# Mobile Intel® Pentium® 4 Processor-M

Specification Update

*October 2006*

Document Number: 250721-036

**Figure 13. System Bus Reset and Configuration Timings**

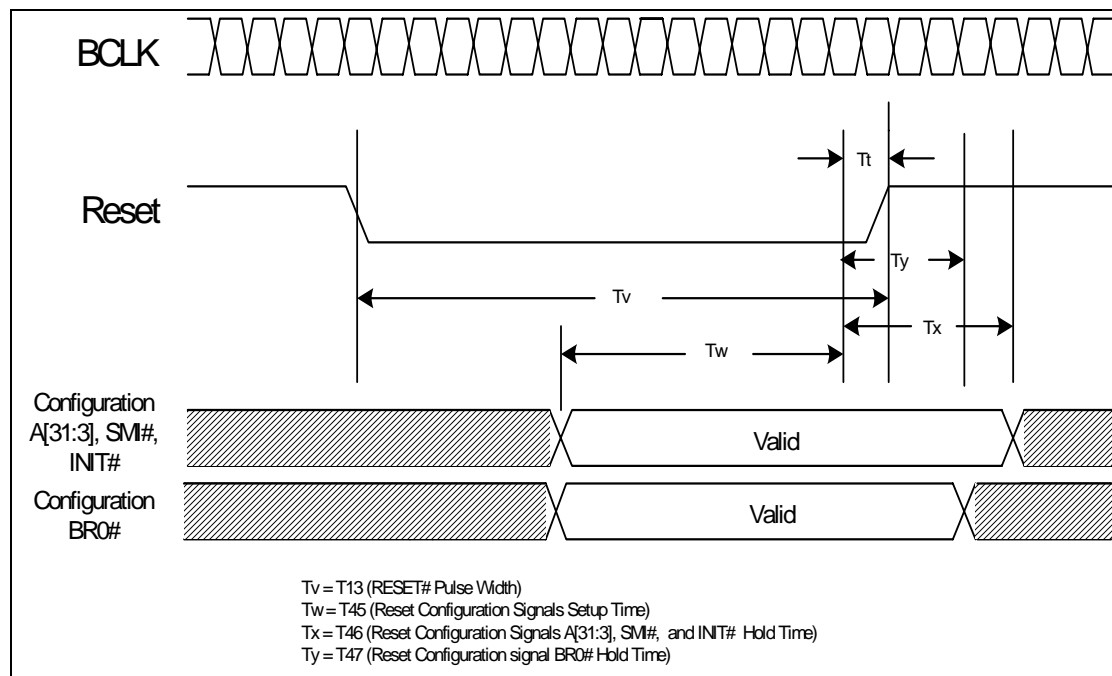
## T2. BR0# Maximum Hold Time Specification Change

The BR0# maximum hold time has changed to 2 BCLKs. This change will be shown in the “System Bus AC Specifications (Reset Conditions)” table and “System Bus Reset and Configuration Timings” figure of the *Mobile Intel® Pentium® 4 Processor - M Datasheet*. This change will be incorporated in the next revision of the datasheet.

The following figure will be modified to reflect this change:

T# Parameter	Min	Max	Unit	Figure	Notes
T45: Reset Configuration Signals (A[31:3]#, BR0# INIT#, SMI#) Setup Time	4		BCLKs	13	1
T46: Reset Configuration Signals (A[31:3]#, INIT#, SMI#) Hold Time	2	20	BCLKs	13	2
T47: Reset Configuration Signal BR0# Hold Time	2	2	BCLKs	13	2
